1 July 2025

Our Ref: 240065-M
Reissue of: 240065-J

Geotechnical Response to Council Queries Delmore Residential Development

Results
GLE / Morgenstern-Price
Surfaces with a factor of safety below 1.000

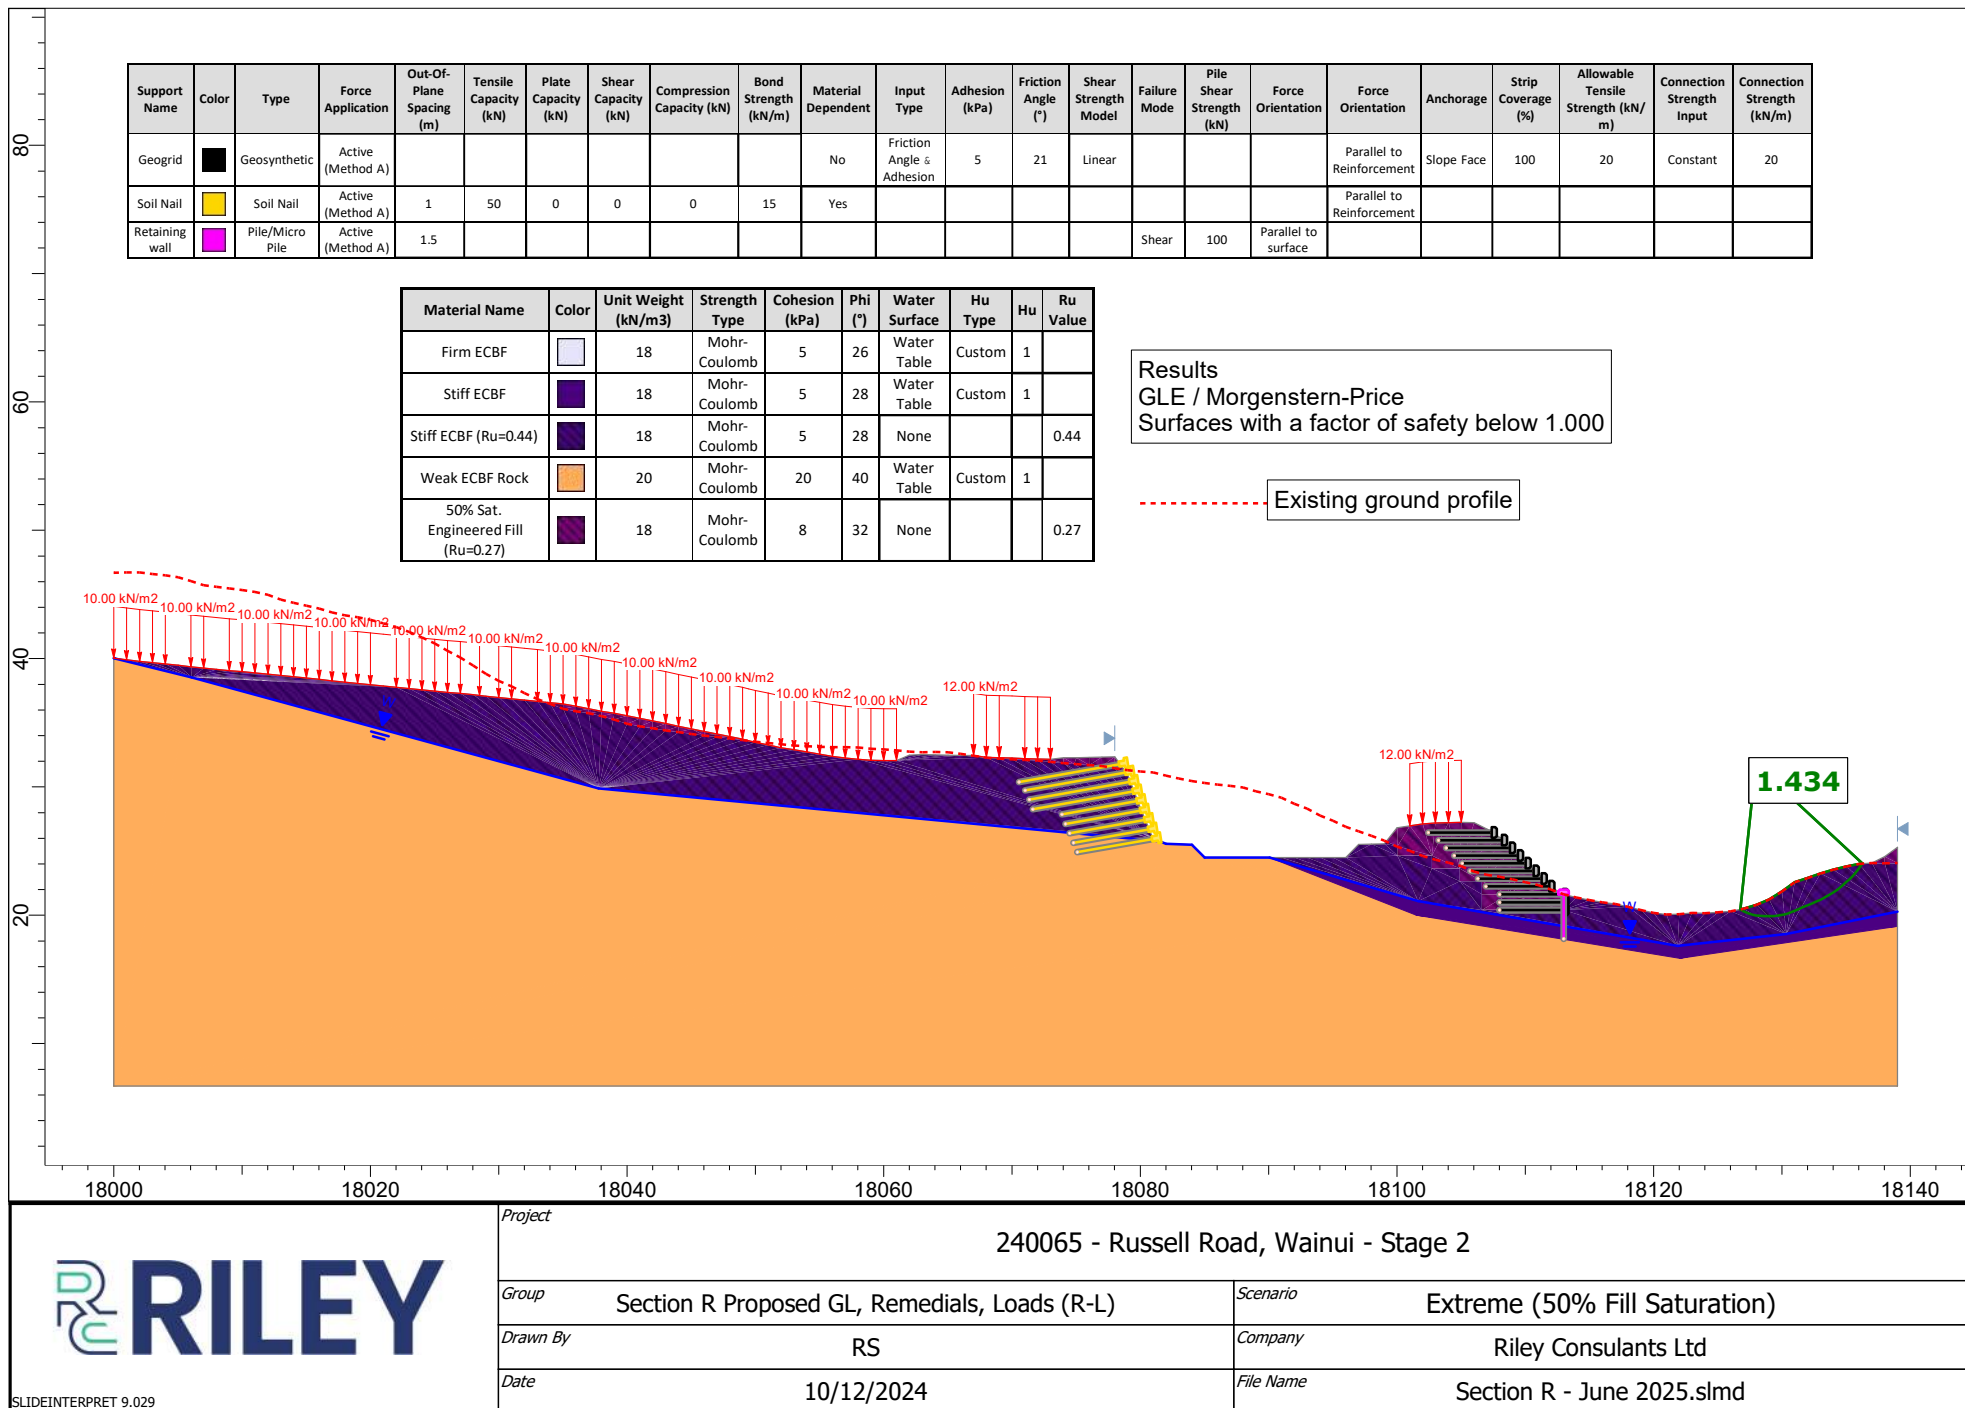
The stability analysis assumes that the fill material is completely dry. However, porewater pressure could potentially develop within the fill, particularly in the event of drainage system failure. Therefore, the potential effects of porewater pressure should be considered in the stability analysis to ensure a more conservative and realistic assessment.

However, as agreed with the Auckland Council Geotechnical Specialist, Riley has reanalysed the slope stability of a selection of eight cross sections to also include 50% saturation of the engineered fill as part of the extreme groundwater scenario (in addition to the post-development surcharges included in our response to Query 19 above). Riley and the Council Specialist agreed that a target FoS of 1.0 would appropriate given that it would take a very extreme rainfall event to result in the fill becoming saturated to this degree. An equivalent Ru value of 0.27 was adopted in the SLIDE2 models to simulate 50% soil saturation. All eight sections analysed under these conditions returned FoS values greater than 1 within the development area, indicating that slope instability is unlikely in this scenario. Some of the models returned minimum FoS values less than 1.0, however, these failure planes are all located on natural slopes remote from the development area and any stability enhancement features, i.e. the FoS in these areas is not reduced from pre-development FoS for this scenario. Slope stability outputs are appended to this letter.

The analysis undertaken to address this query, assumes that the subsoil drains have become ineffective (e.g. blocked or impaired function). The subsoil drainage to be installed as part of the development will utilise TNZ F/2 compliant drainage material. In Riley's experience, this grade of drainage material adequately mitigates the risk of subsoil drainage becoming blocked or needing long-term maintenance. For this reason, Riley considers that the proposed subsoil drainage should not require an Operation and Maintenance Plan during the design life of the drains.
